# Oakland City Planning Commission

## STAFF REPORT

Case File Number: PLN18523

<b>Location:</b>	98 <sup>th</sup> and San Leandro (921 98 <sup>th</sup> Ave)
<b>Assessor's Parcel Number(s):</b>	044 508018000 and 044 508017900
<b>Proposal:</b>	Preliminary Development Plan (PDP) for a Planned Unit Development at 98 <sup>th</sup> and San Leandro, including 369 residential units, 35 work/live units, and 2,468 sf of ground-floor commercial space.
<b>Applicant:</b>	Fleischmann Property, LLC
<b>Contact Person/ Phone Number:</b>	Claire Han, 510-452-2944
<b>Owner:</b>	Fleischmann Property, LLC
<b>Case File Number:</b>	PLN18523
<b>Planning Permits Required:</b>	PDP, Variance for work/live units, Design Review, Vesting Tentative Tract Map, compliance with CEQA
<b>General Plan:</b>	Housing and Business Mix
<b>Zoning:</b>	HBX-1
<b>Environmental Determination:</b>	TBD
<b>Historic Status:</b>	Non-Historic Property
<b>City Council District:</b>	CCD7, Larry Reid
<b>Finality of Decision:</b>	NA
<b>For Further Information:</b>	Contact Case Planner Dara O'Byrne at 510-238-6983 or by e-mail at <a href="mailto:dobyrne@oaklandca.gov">dobyrne@oaklandca.gov</a>

## 98TH AVENUE | 98TH AVENUE FRONTAGE ENLARGEMENT

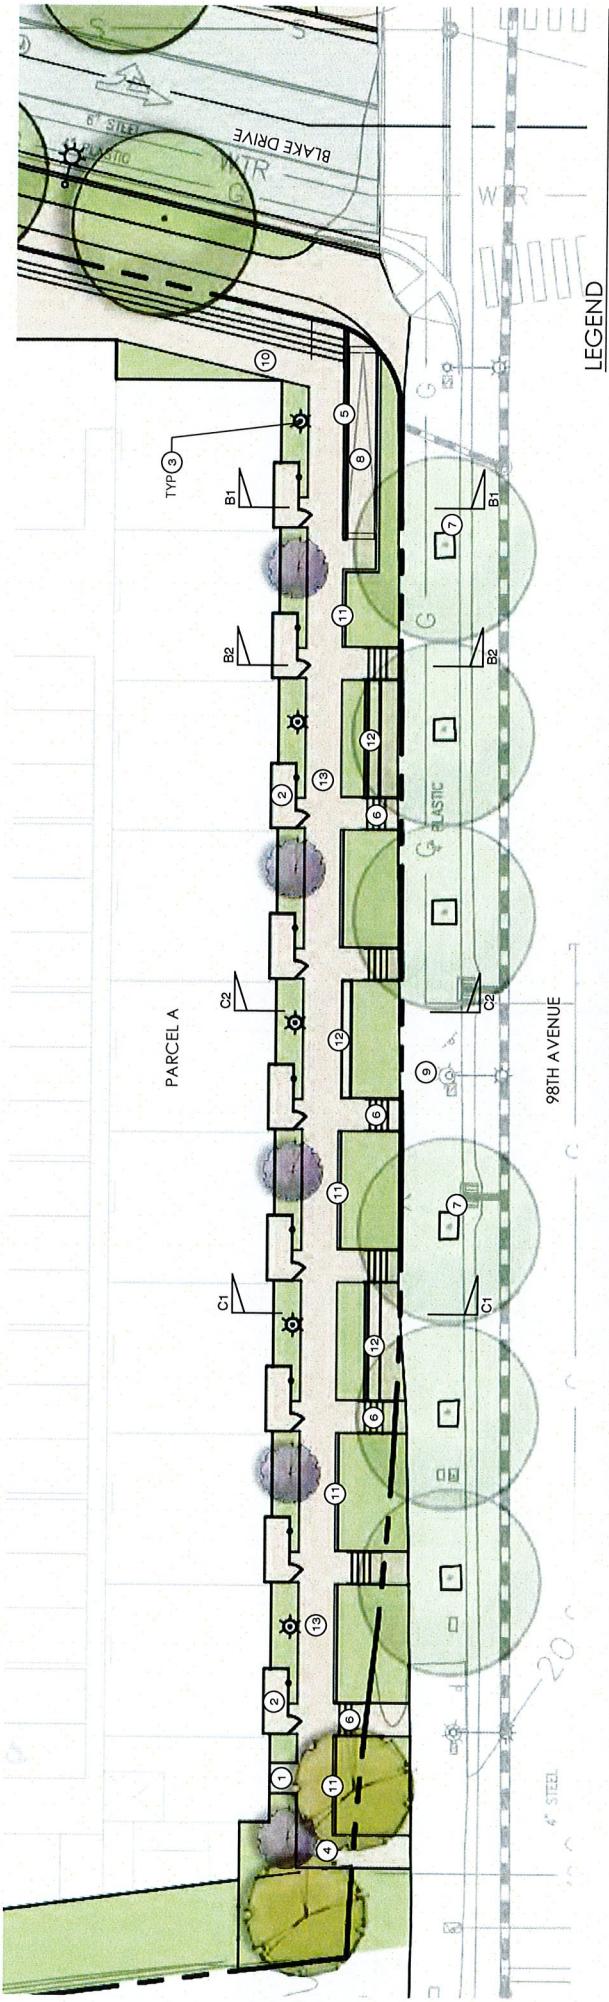
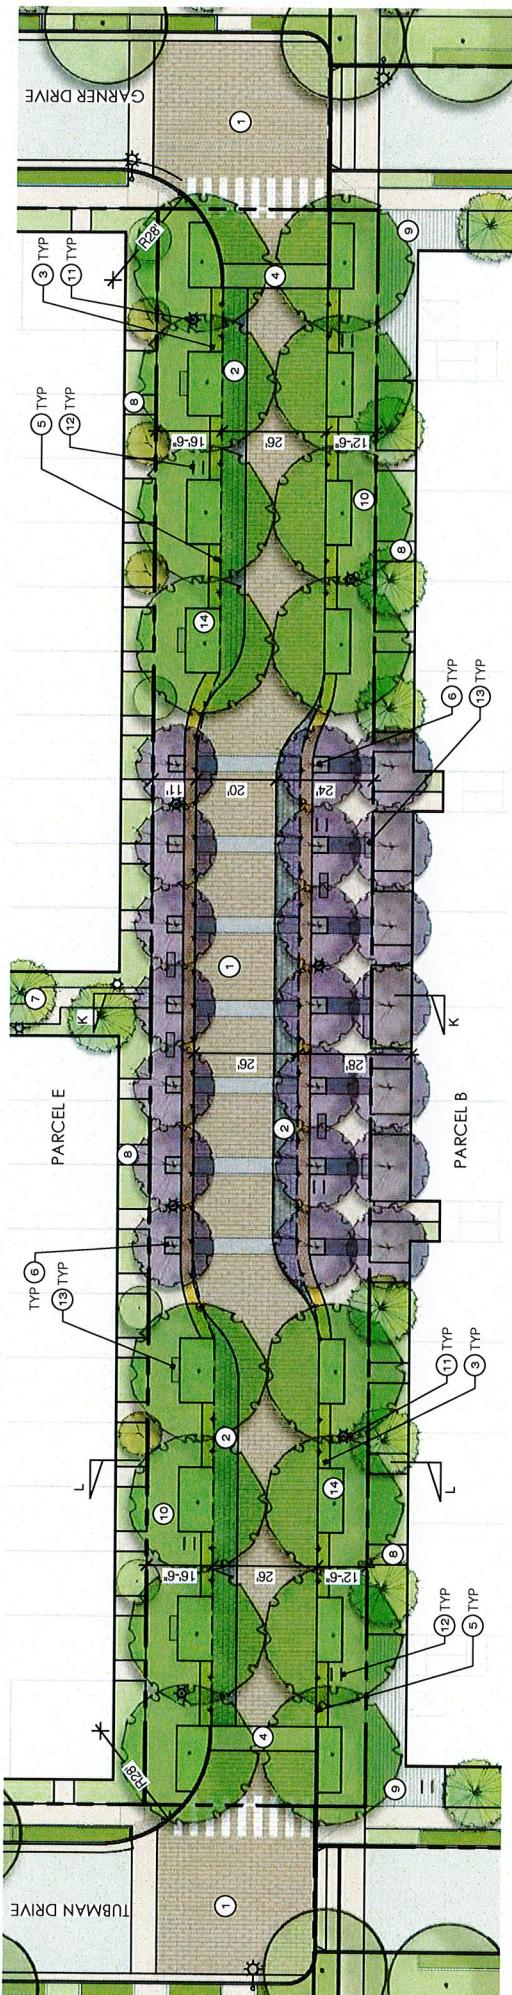
- *The work/live units facing 98<sup>th</sup> Ave have too many barriers between the business door and the sidewalk to meet this criteria, including stairs, a setback, and a gate. Staff recommends removing the gate and the fence enclosing the patio to create a more obvious and welcoming business entry. The other work/live units do not have enough design detail to analyze, but the design guidelines and future FDPs should comply with these criteria.*

- *The work/live units facing 98<sup>th</sup> Ave have too many barriers between the business door and the sidewalk to meet this criteria, including stairs, a setback, and a gate. Staff recommends removing the gate and the fence enclosing the patio to create a more obvious and welcoming business entry that is conveniently accessible. The other work/live units do not have enough design detail to analyze, but the design guidelines and future FDPs should comply with these criteria.*

*The work/live units should provide storefront sized windows and entrances with transparent glazing at the front façade, and the Design Guidelines should reflect this. Currently, the designs for the work/live units facing 98<sup>th</sup> and San Leandro provide storefront windows, but the entryways are separated by stairs, a setback, and a gate.*

- *The work/live units need to provide a more prominent entrance by removing the gate and fenced patio, which gives the appearance of a residential unit.*

- **Work/Live Units Facing 98<sup>th</sup> Ave.** As currently designed, the work/live units facing 98<sup>th</sup> Ave. do not meet the zoning requirements for Type 3 units, requiring a Minor Variance, and do not meet the design review criteria for work/live units. The applicant has incorporated the setback and elevation of the work/live units to buffer the work/live units from the traffic on 98<sup>th</sup> Ave, but the design features make the units appear like residential entries instead of commercial entries that are open to the public. Staff is willing to support the Minor Variance if the commercial uses are better connected to the street. Staff recommends that, at a minimum, the gates to each business door and the fenced patio be removed to create a better connection. The connection between the street and the commercial entryways should be more porous. The elevated walkway in front of the entries could also be widened to create more of a gathering place, to mimic places like Yaletown in Vancouver, Pearl District in Portland, or even along 4<sup>th</sup> Street in Berkeley.

- *Does the DRC think the elevated, setback work/live units with gates meets the design intent of work/live units? Do you have suggestions about how these units can be designed to better meet the design criteria?*
